Rezoning Application: PD 22-1390
Zoning Hearing Master Date: June 20, 2023
BOCC Land Use Meeting Date: August 8, 2023

APPLICATION NUMBER: PD 22-1390

AGENCY REVIEW COMMENT SHEET

8.0 PROPOSED SITE PLAN (FULL)

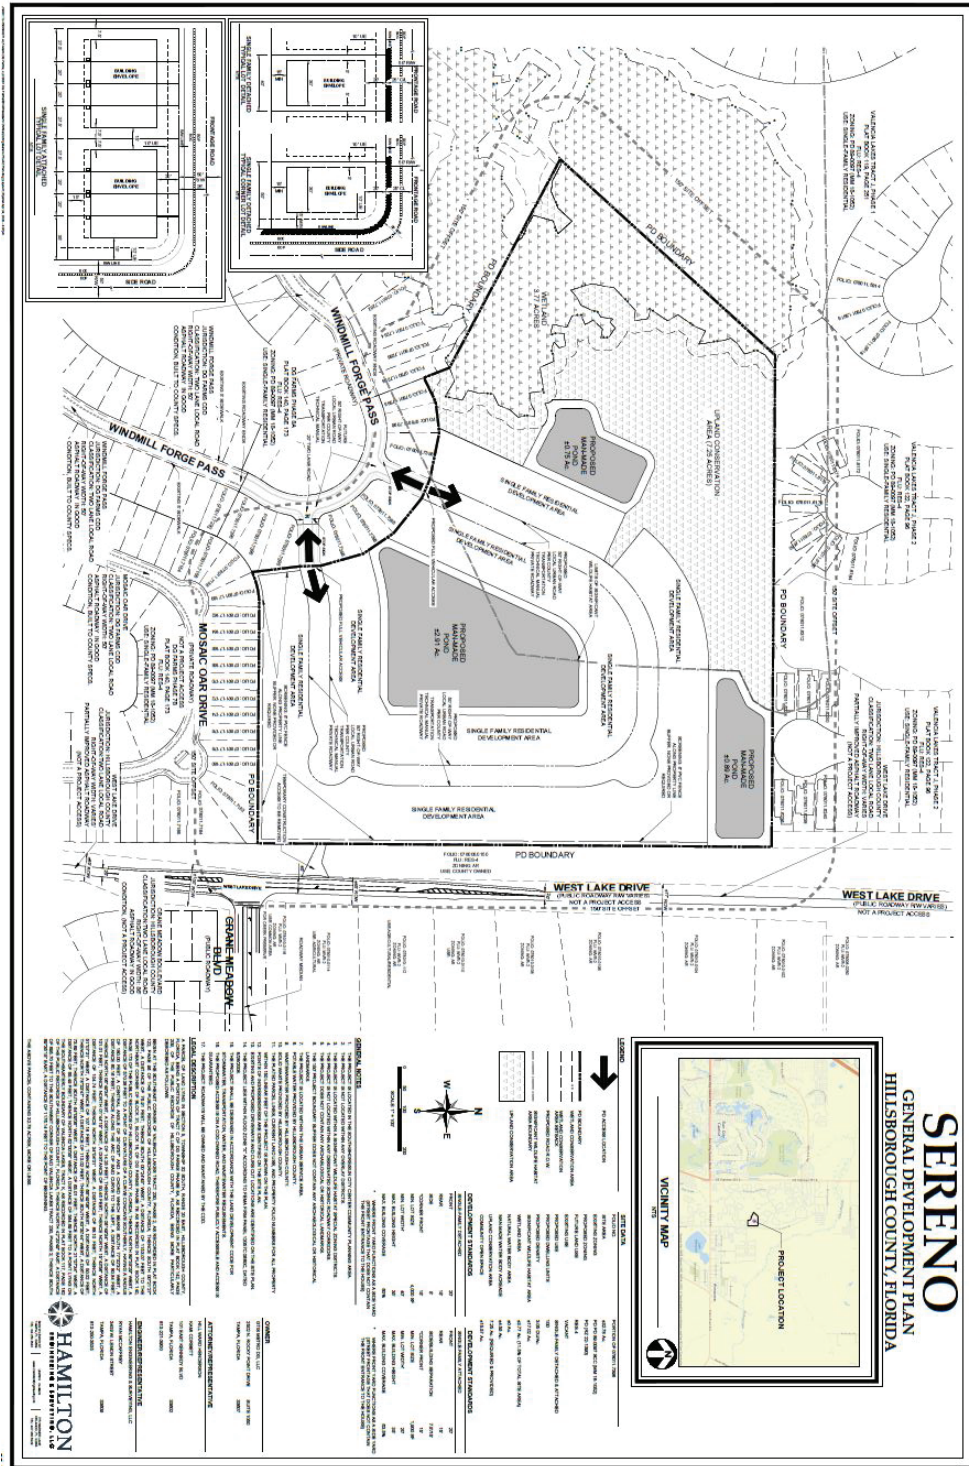
- 1. Maximum building coverage to be removed for both lot types.
- 2. Add a note that reads "Sidewalks to be provided per the Hillsborough County Land Development Code."

Prior to PD site plan certification, the applicant shall revise the PD site plan to:

- Add a note that reads “Sidewalks to be provided per the Hillsborough County Land Development Code.”

GENERAL DEVELOPMENT PLAN HILLSBOROUGH COUNTY, FLORIDA

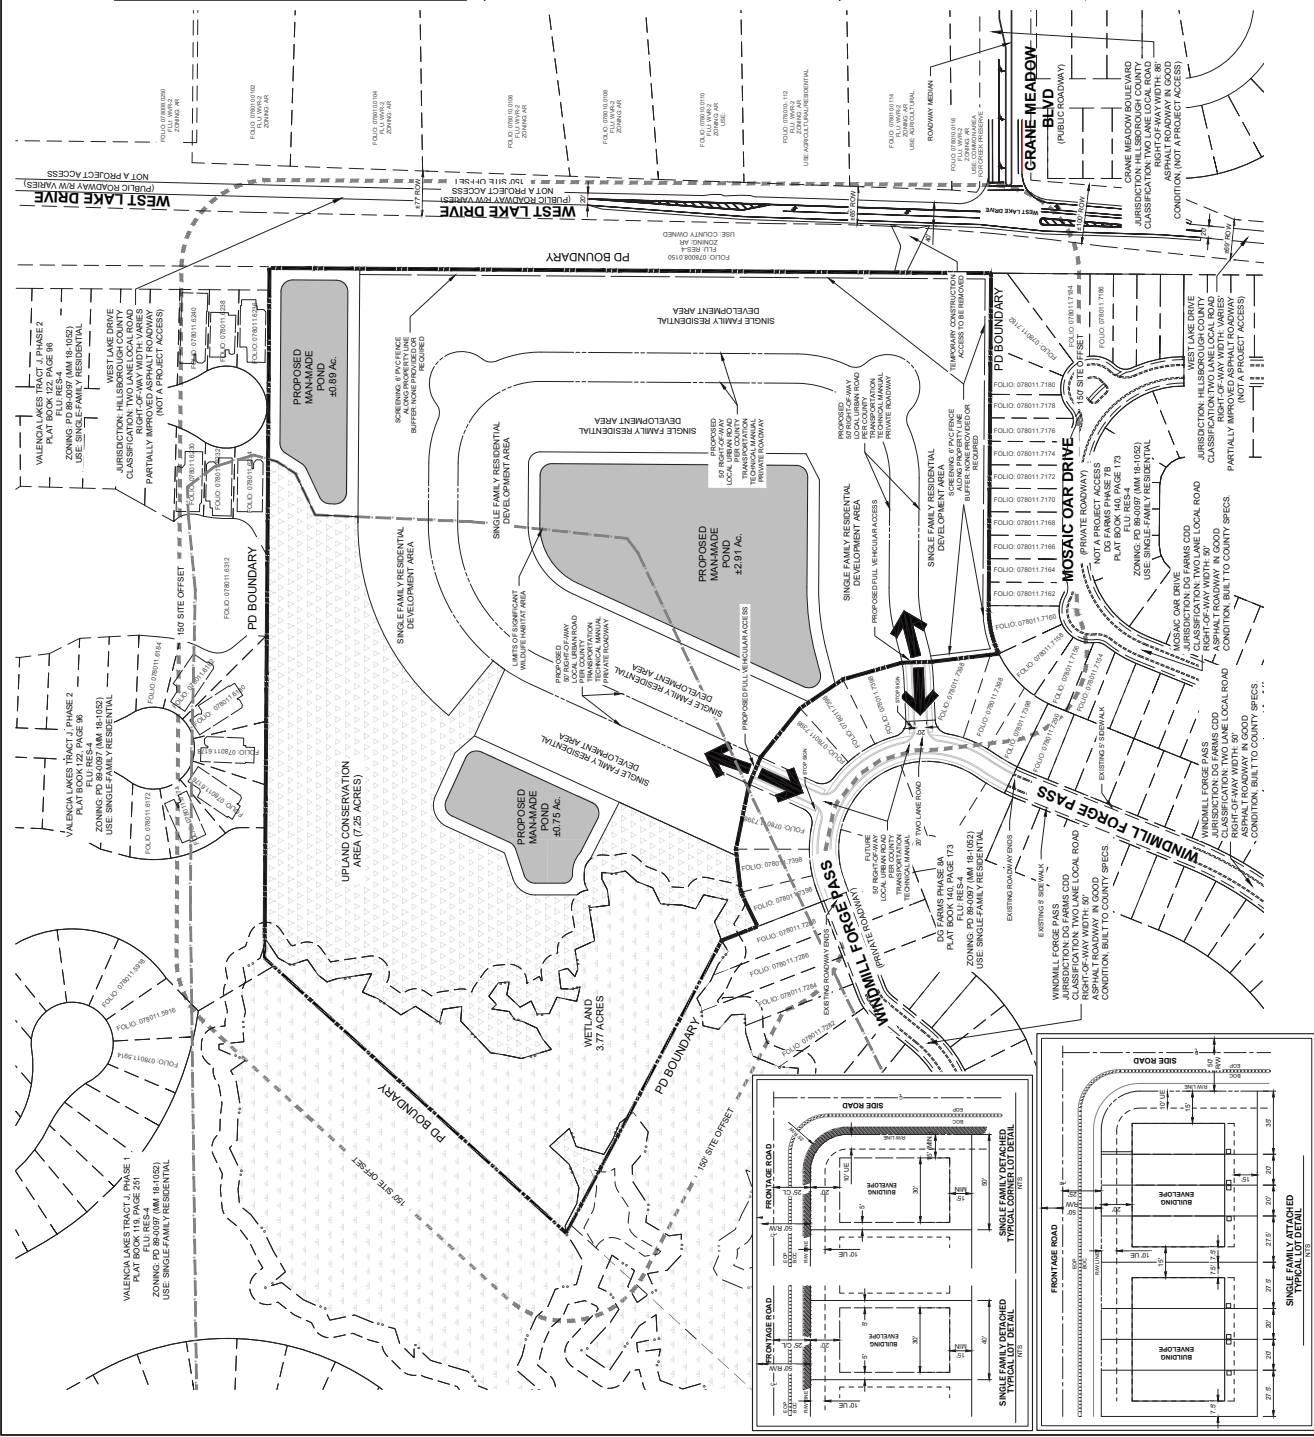
1. The proposed location of the 7.25 acres of Upland Conservation Area as shown on the plans submitted on April 24, 2023, is acceptable with the exception of the area located between proposed lots. This square footage will need to be incorporated into the main conservation area to maintain the minimum acreage requirement for conservation.

Additionally, recent aerial images indicate that a portion of the mapped Significant Wildlife Habitat area on this site has been disturbed. This area will either need to be restored, or will be subtracted from the acreage that will credit toward the required acreage to be preserved. This will be determined during the construction plan review, and may result in additional adjustments to the location of the Upland Conservation Area and the number and location of proposed lots.
